Development Services Department
Staff Recommendations Concerning Required Findings

Project: Courtyard Final Plat and Subdivision
Ordinance Standard: Watershed Protection Ordinance
Variance Request: To vary from LDC 25-8-301, prohibiting construction of a driveway on slopes greater than 15 percent, unless to provide primary access to an area of at least 2 contiguous acres with a slope of less than 15 percent, or at least five residential units.

Case Name	Courtyard Final Plat and Subdivision
Case Number	C8-2018-0032.0A
Address or Location	6910 WEST COURTYARD DR
Environmental Reviewer Name	Pamela Abee-Taulli
Applicable Ordinance	LDC 25-8-301
Watershed Name	West Bull Creek
Watershed Classification	<input type="checkbox"/> Urban <input checked="" type="checkbox"/> Suburban <input type="checkbox"/> Water Supply Suburban <input type="checkbox"/> Water Supply Rural <input type="checkbox"/> Barton Springs Zone
Edwards Aquifer Recharge Zone	<input type="checkbox"/> Barton Springs Segment <input type="checkbox"/> Northern Edwards Segment <input checked="" type="checkbox"/> Not in Edwards Aquifer Zones
Edwards Aquifer Contributing Zone	<input type="checkbox"/> Yes <input checked="" type="che

DRAINAGE AREA MAP, SLOPE AREA MAP
& DRIVEWAY PROFILE

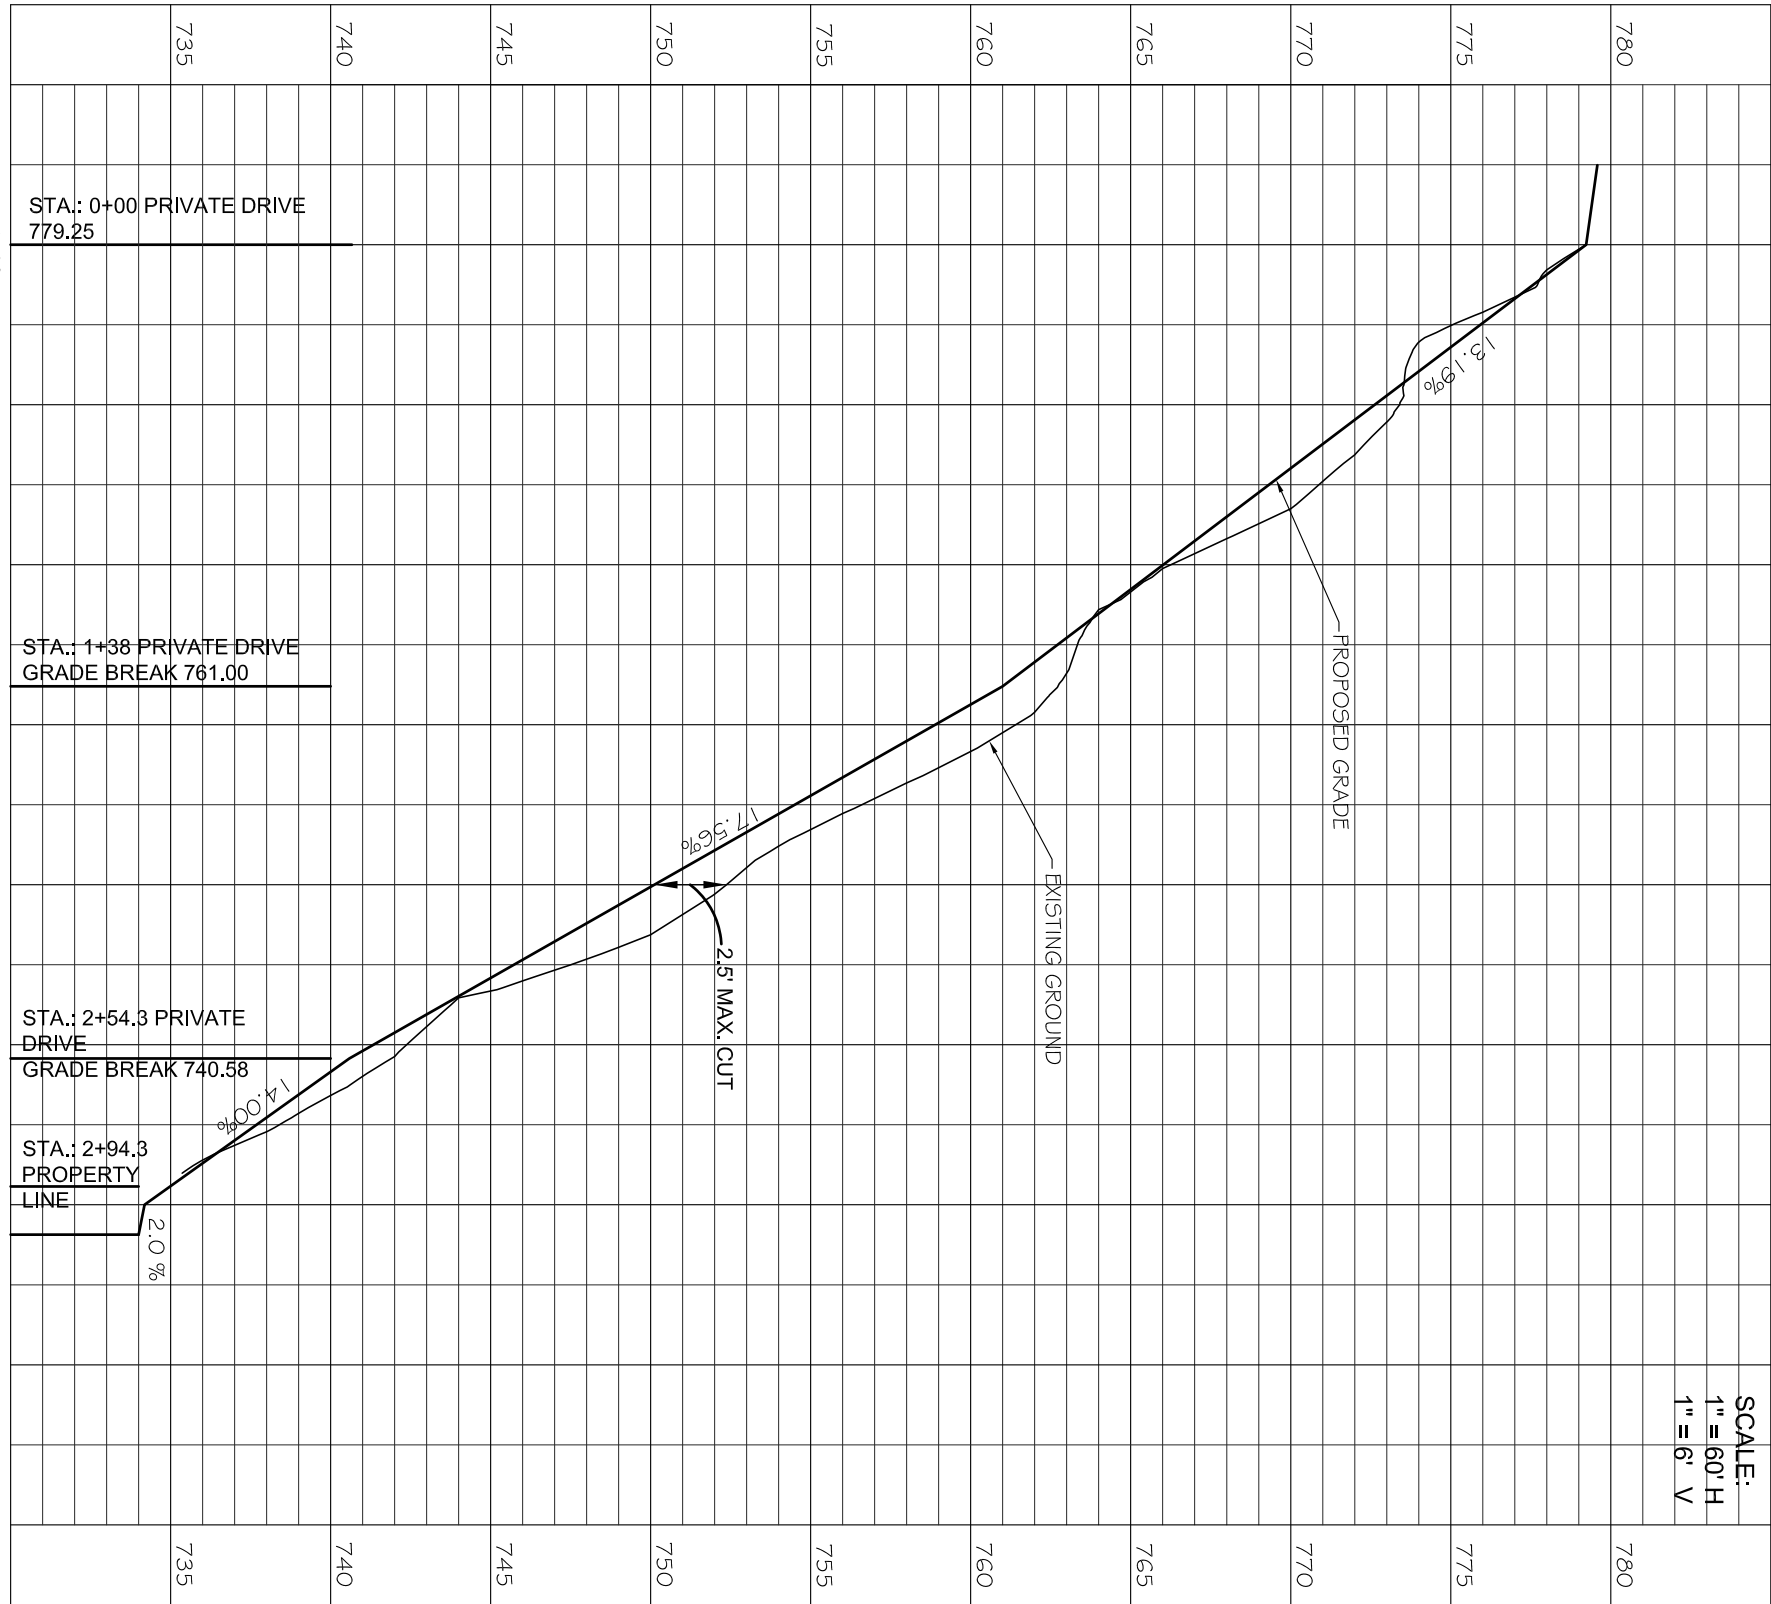
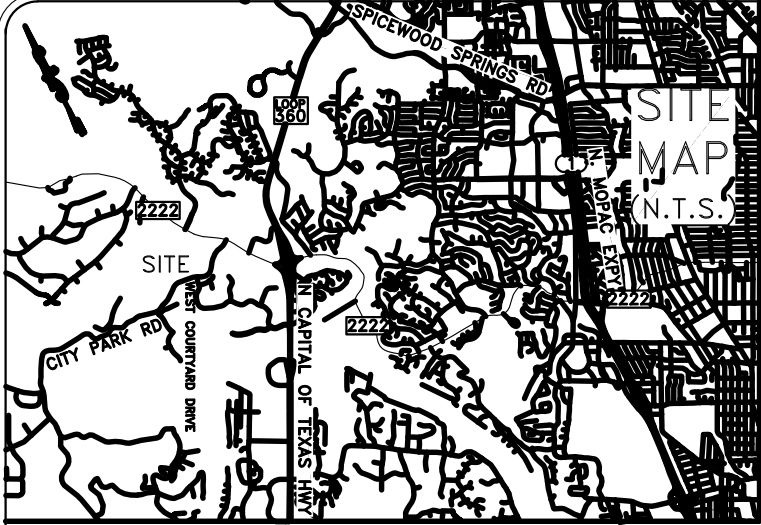
No The variance is necessitated by the applicant's proposal to subdivide the existing lot in a manner that would create a lot for which a driveway could not be constructed in compliance with LDC 25-8-301. That is, a driveway would have to cross slopes greater than 15 percent, to provide primary access to an area of less than 2 acres with a slope of less than 15 percent, to reach a single residential unit.

No The construction on steep slopes that would be necessary to develop a driveway access to a residence would create a significant probability of harmful environmental consequences.

Yes The request for a variance is not based on a condition caused by a method chosen by the applicant to develop the property. Due to the steep topography of the site, there is no possible configuration of a driveway on the property connecting the street to the home that

does not cross a 15% slope. This particular configuration of the driveway was selected to reduce the length of the driveway and, thereby, reduce the amount of overall impervious cover; any alternative configuration would lead to a longer driveway and would still cross a 15% slope.

Yes The location selected for the driveway allows for close proximity to the proposed single family residence which results in a shorter driveway length and a reduction in the impervious cover. As a result, this location will not create a significant probability of harmful environmental consequences. Also, this location provides for safe stopping sight distances from Finklea Cove. All methods of erosion and sedimentation controls will be employed during the construction of the driveway.
